## **Quarterly Report** *(All fields required)*

**Project Title:** Barker's Island Beach Restoration Project

**Report Prepared by:** AMI Consulting Engineers, PA

STAKEHOLDERS’ MEETING MINUTES

BARKERS ISLAND BEACH RESTORATION	
BARKERS ISLAND SUPERIOR, WI	SITE PLAN 30% LAYOUT
JOB No: 171276	DATE: 12/20/2017
DRAWN BY: AJP	DESIGNED BY: ECR
SHEET:	
<b>C2.2</b>

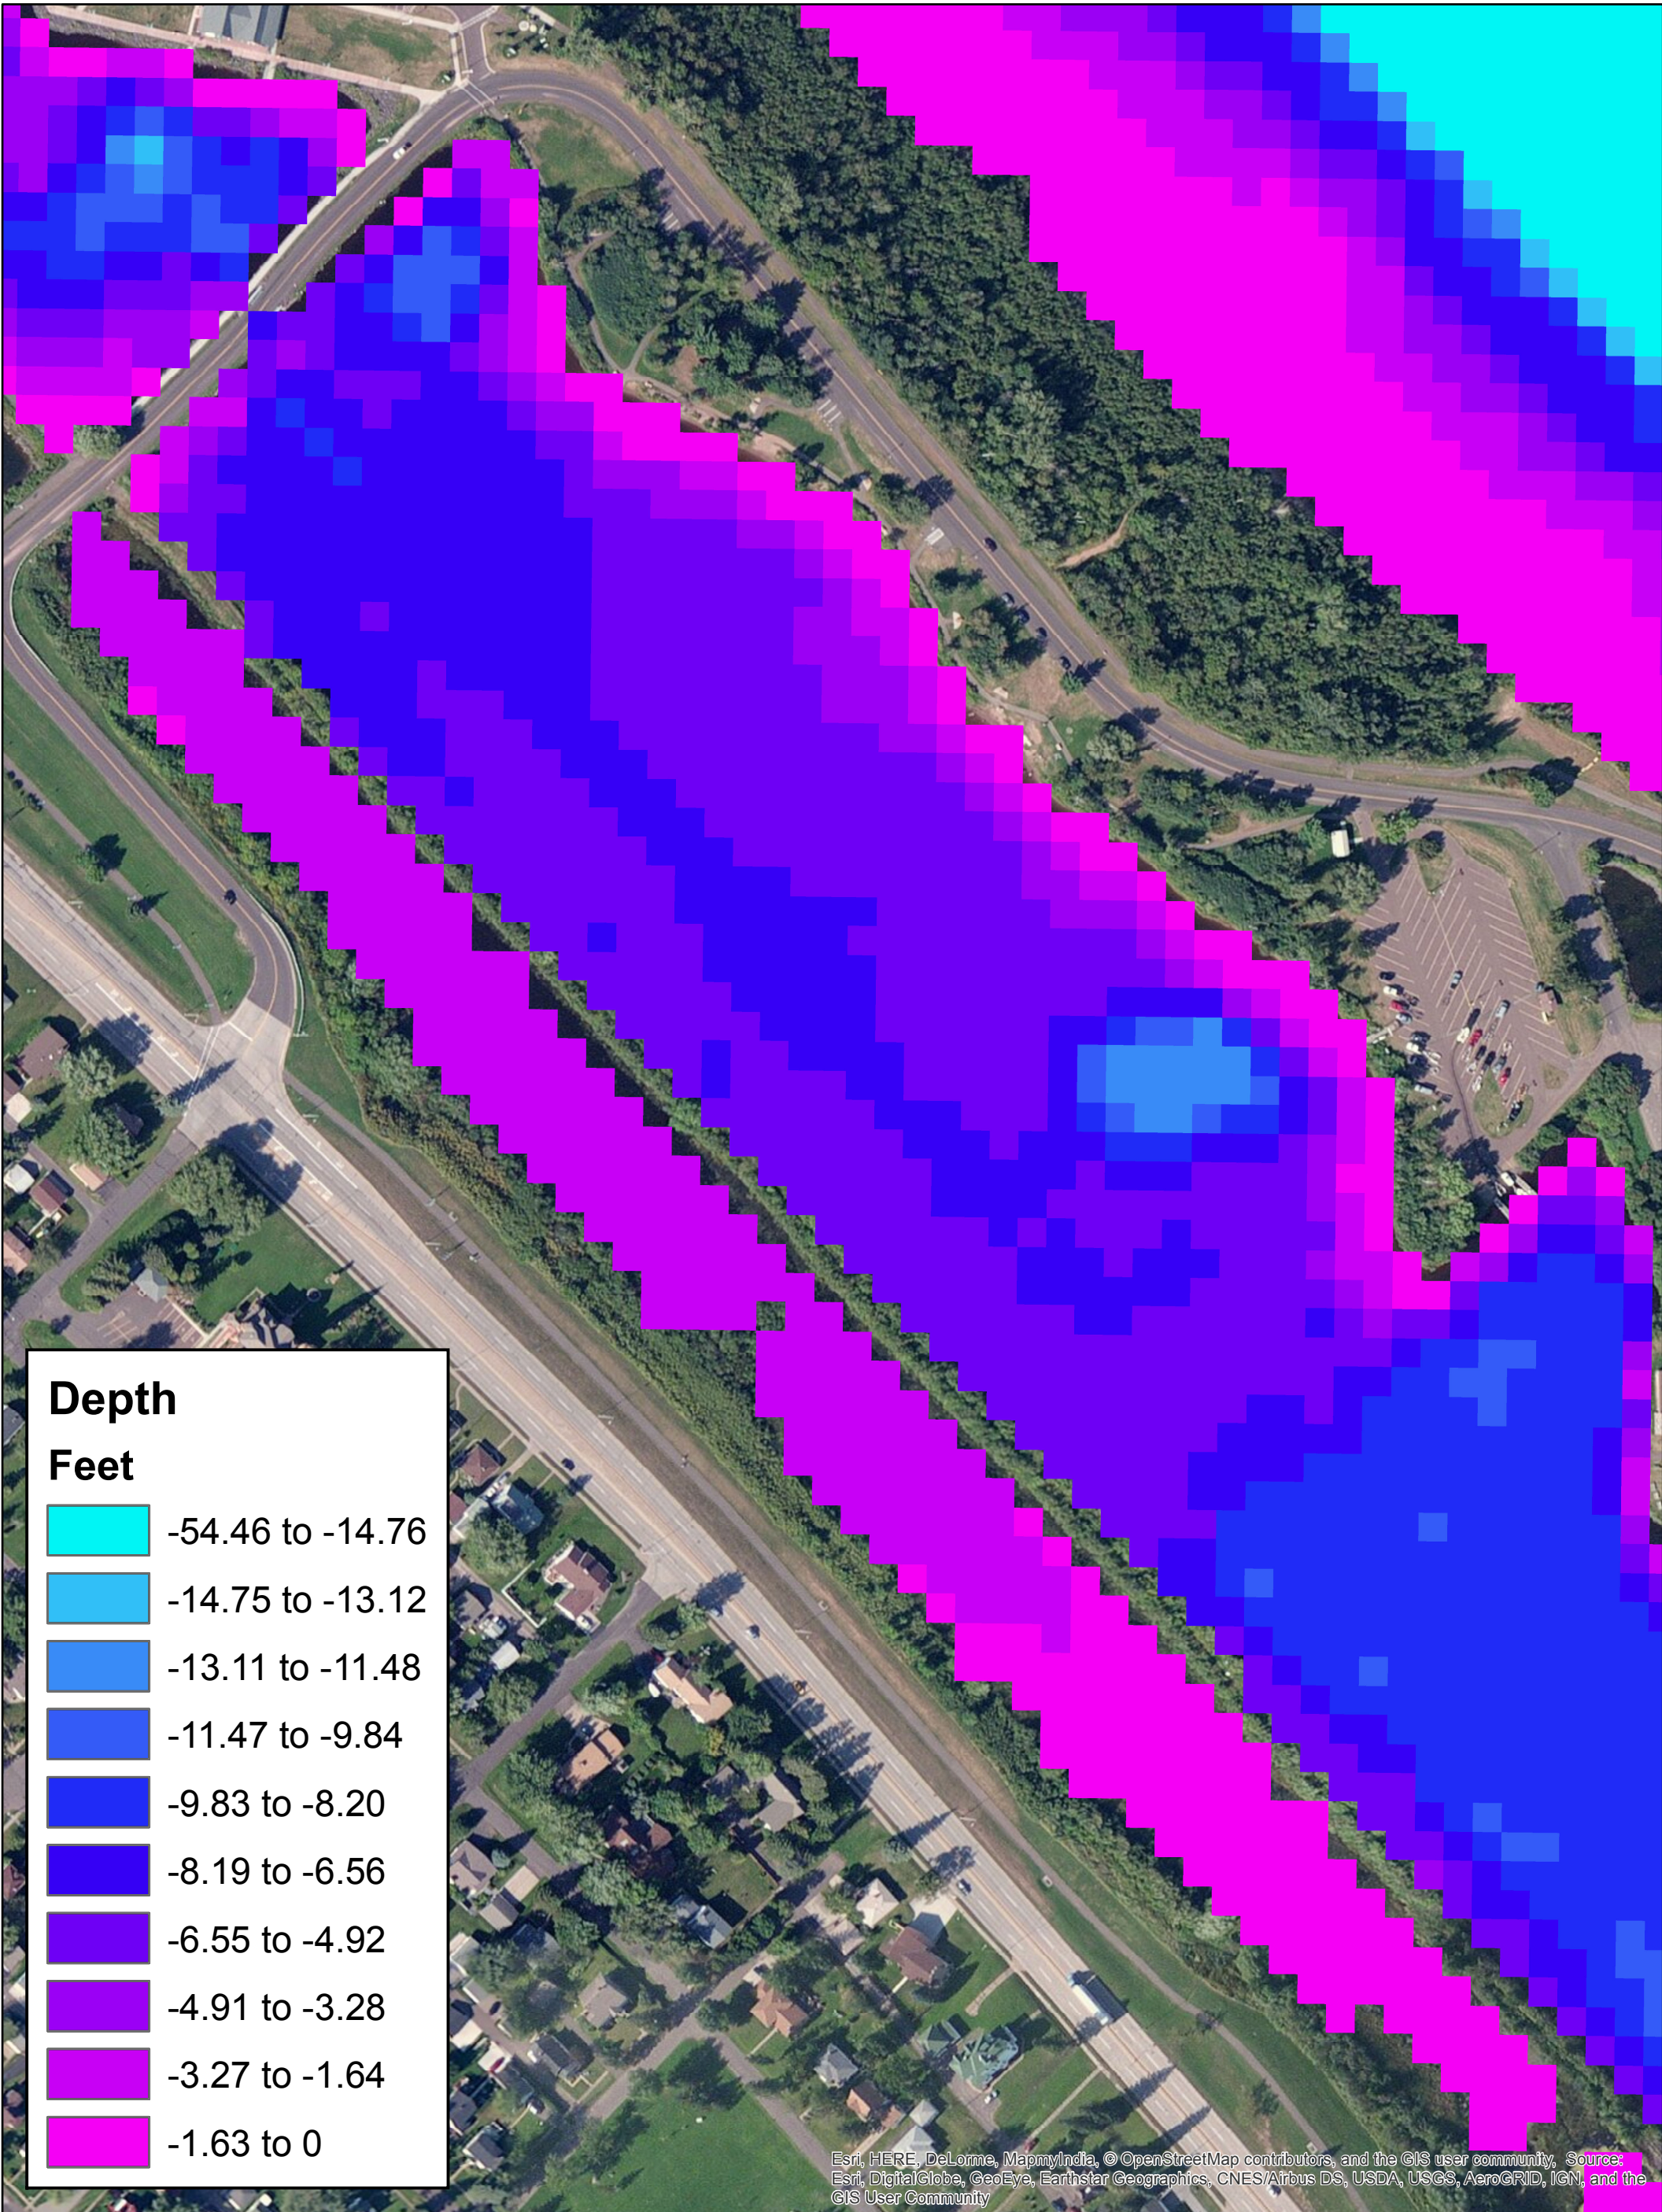
Discussed conceptual plans. Linda stated that the City Park Board meeting recommended the plan option depicted on map C2.2. The stakeholders in attendance were also in favor of that plan approach.

Stakeholders generally were in favor of the proposed location and size of the beach area on plan C2.2. Coarse, dry sand beach was recommended with frequent beach grooming maintenance required. Discussed options for a retaining wall along the beach to discourage waterfowl. Beach drop-off limit was suggested that it should be roped off and marked at the six-foot or shallower depth. Linda had concerns about the nature of the sediment materials underwater and depth of the water in the swimming area and whether any dredging or filling would be required. Matt mentioned J. Austin UMD hydrologic model to review flow gradients in the area. Steve had suggested pulling the sand away from the shoreline in the fall to prevent sand from moving into the water as part of the ice movements.

Also discussed adding some vegetated areas to limit waterfowl movement through the beach past the proposed boardwalk location. Specific boardwalk accesses, possibly with steps to beach area should be identified on the plans.
